**Re: Defect Information Report – Supplemental Report No. 3  
07V-306, FL-501, AAC Front Axle Steering Arm Bolts**

## Subject: AAC Front Axle Tie Rod and Steering Arm Fasteners

December 2007  
 FL501A  
 NHTSA #07V-306

Subject: RECALL 07V-306 – AAC Front Axle Tie Rod & Steering Arm Fasteners

**Fig. 1, Steering Arm and Tie Rod Arm**

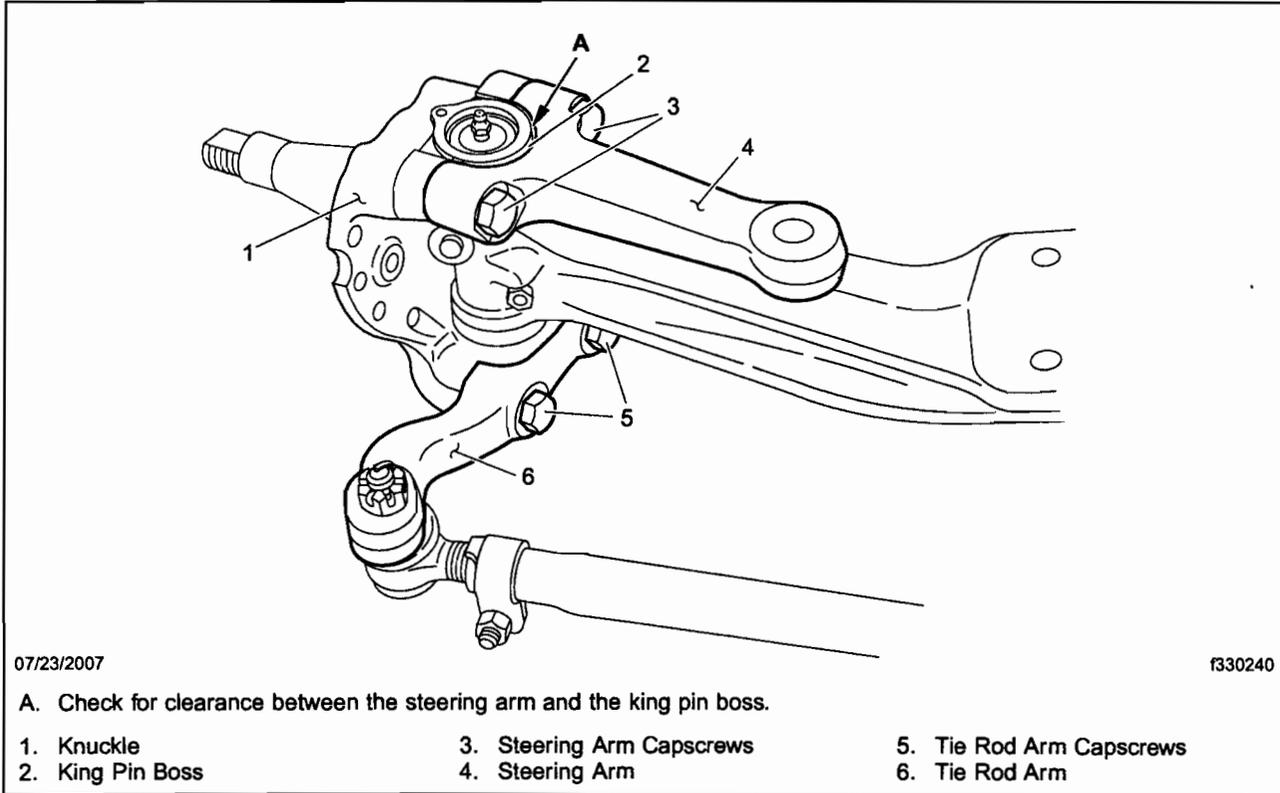
During front axle assembly, the fasteners that attach the steering arm or the tie rod arms to the spindle may have been over or under tightened. Incorrectly tightened fasteners may fatigue and fracture, resulting in a possible vehicle crash without prior warning.

1. Check the base label (Form WAR259) for a completion sticker for FL501 (WAR260) indicating this work has been done. The base label is usually located on the passenger-side door about 12 inches (30 cm) below the door latch on trucks, over the driver's window in school buses, on the front wall under the dash in motorhomes, or in the driver's area in step vans. If a completion sticker for FL501 is present, nothing more needs to be done. If no sticker is present, go to the next step.
2. Shut down the engine, and chock the front tires.
3. Using a 0.004 inch (0.1 mm) feeler gauge, check the clearance between the steering arm and the king pin boss. See Fig. 1.

1. Remove one of the capscrews that attaches the steering arm to the steering knuckle. See Fig. 1.
2. Check the capscrew threads to verify whether Loctite® or another thread locking compound was applied to them.

3. Apply Loctite 277 to the threads of a new M20 x 1.5 x 80 capscrew from the Recall kit.
4. Install the new steering arm capscrew and tighten it 425 lbf-ft (575 N-m).
5. Repeat steps 1 through 4 to replace the second capscrew.
6. Continue with the "Tie Rod Arm Capscrew Replacement" procedure in these Work Instructions.

1. Remove one of the capscrews that attaches the tie rod arm to the knuckle. See **Fig. 1**.
2. Check the capscrew threads to verify whether Loctite® or another thread locking compound was applied to them.

3. Apply Loctite 277 to the threads of a new M20 x 1.5 x 90 capscrew.
4. Install the new tie rod arm capscrew and tighten it 425 lbf-ft (575 N·m).
5. Repeat steps 1 through 4 until all four of the tie rod arm capscrews have been replaced.
6. Clean a spot on the base label (Form WAR259) and attach a completion sticker for Recall FL501 (Form WAR 260) to the base label.
7. Remove the chocks.

3. Apply Loctite 277 to the threads of two new M20 x 1.5 x 80 capscrews.
4. Install a new steering arm with its engraved part number facing upward.
5. Install the new steering arm capscrews and tighten them 425 lbf·ft (575 N·m).
6. Go to the "Tie Rod Arm Capscrew Replacement" procedure in these Work Instructions.

Figure 1

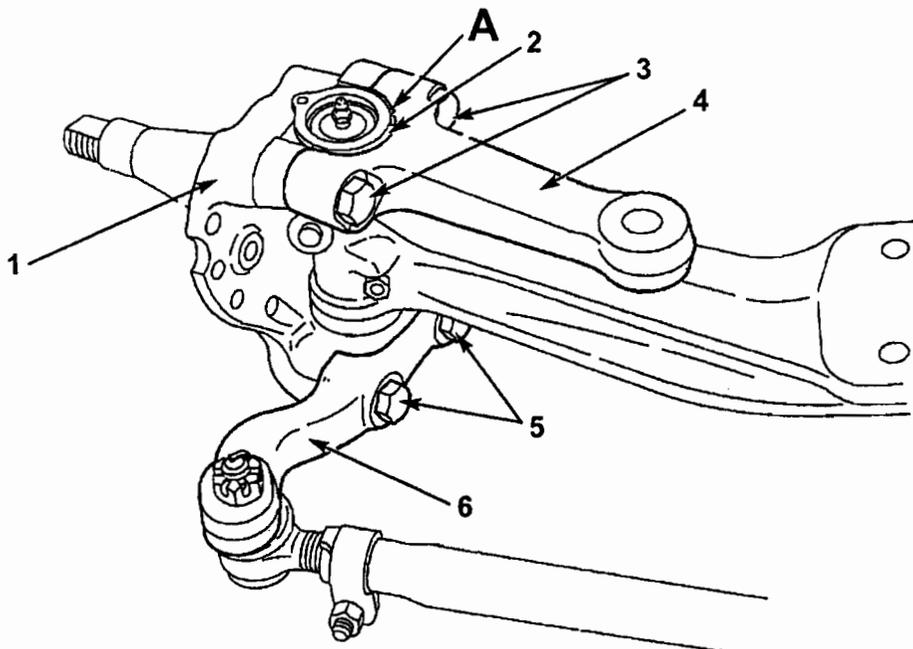
The defect involves the fasteners that attach the steering arm or tie rod arms to the spindle. During front axle assembly these fasteners may be over or under tightened. Incorrectly torqued steering arm fasteners may fatigue and fracture, causing loss of steering, and a crash without warning.

1. Shut down the engine, and chock the front tires.
2. Using a 0.004" (0.1 mm) feeler gauge, check the clearance between the steering arm and the king pin boss. **Figure 1**

### A. Check for clearance between the steering arm and the king pin boss.

1. Remove one of the capscrews that attaches the steering arm to the steering knuckle. **Figure 1**
2. Check the capscrew threads to verify whether Loctite® or another thread locking compound was applied to them.

3. Apply Loctite 277 to the threads of a new M20 x 1.5 x 80 capscrew from the Recall Kit.
4. Install the new steering arm capscrew and tighten it 425 ft/lbs. (575 N·m).
5. Repeat steps 1 through 4 to replace the second capscrew.
6. Continue with the "Tie Rod Arm Capscrew Replacement" procedure.

1. Remove one of the capscrews that attaches the tie rod arm to the knuckle. **Figure 1**
2. Check the capscrew threads to verify whether Loctite® or another thread locking compound was applied to them.

3. Apply Loctite 277 to the threads of a new M20 x 1.5 x 80 capscrew.
4. Install the new tie rod arm capscrew and tighten it 425 ft/lbs. (575 N·m).
5. Repeat steps 1 through 4 until all four of the tie rod arm capscrews have been replaced.
6. Remove the chocks.
